**TESTIMONY OF JOE MEHRA, P.E. PTOE, IN OPPOSITION TO THE 923-925 5<sup>th</sup> Street NW, Hotel, BZA Case No. 19722. (April 4, 2018)**

I have reviewed the Comprehensive Transportation Review (CTR) study prepared by Gorove/Slade, dated March 1, 2018 and the DDOT Report dated March 14, 2018. Based on my review, I conclude that the Gorove/Slade CTR is incomplete and does not meet the CTR Guidelines. Further, the Loading Dock access would not function based on the data and information provided by Gorove/Slade in their report. The proposed use is a 153 room hotel with a 120 seat restaurant/bar. The site is located in the D-4-R and is not required to provide vehicle parking. The Applicant proposes to meet the needs of guests who wish to drive to the site by offering off-site valet service. As proposed, guests will drop their cars in a valet zone fronting the building on 5th Street, and an attendee will park the car at a garage within the vicinity of the site.

Exhibit 5

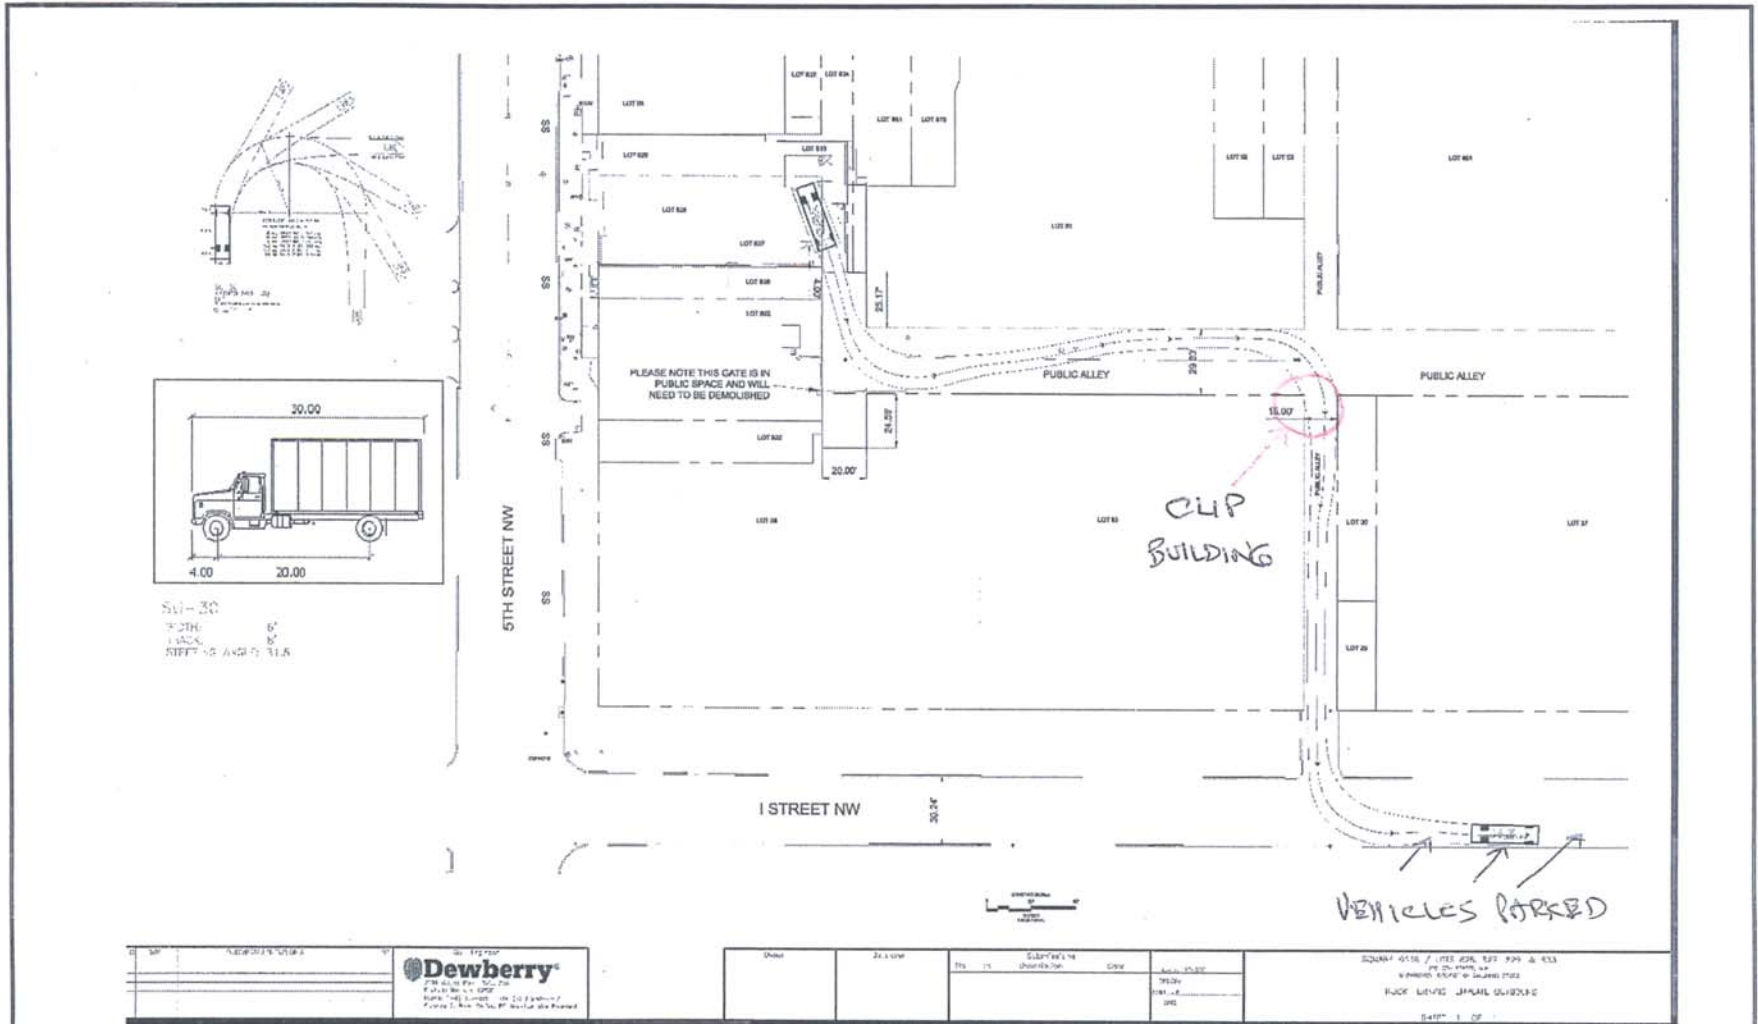
The Gorove/Slade AutoTURN shows that the trucks will clip the I Street building on the east side as it leaves the loading dock (See Exhibit 5). Further, the outbound movement from the loading dock looks to be touching edge of the loading dock wall. Finally and very important the AutoTURNs do not take into account the on-street parking on both sides of I Street NW (inbound and outbound). There is on-street parking on both sides of I Street and leaves approximately 14 feet space between the vehicles parked on both sides. The AutoTURN shows that the truck will not be able to turn in to the alley or turn out of the alley due to vehicles parked on I Street (See Exhibits 5 and 6).

Exhibit 6

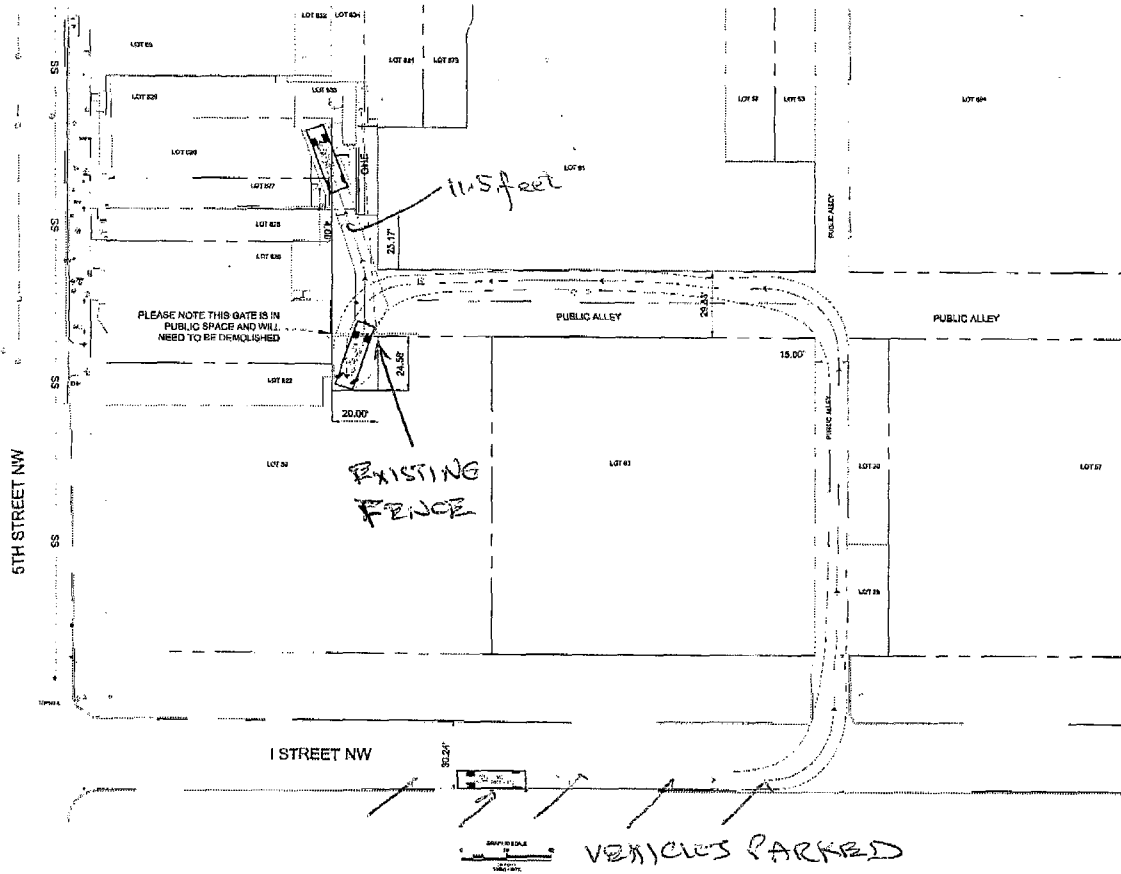
As per DDOT, the site's alley access is constrained by existing walls on adjacent properties, limiting the entry aisle of the alley to be 11.5-feet wide (See Exhibit 6). As such, the Applicant may need to request additional zoning relief from subtitle C § 904.5. The trucks will need to back into the proposed angled space of 11.5 feet, which will require the removal of an existing fence at the alley's hammerhead. The backing movement would require the assistance of another person to guide the driver in to the narrow angled loading dock.
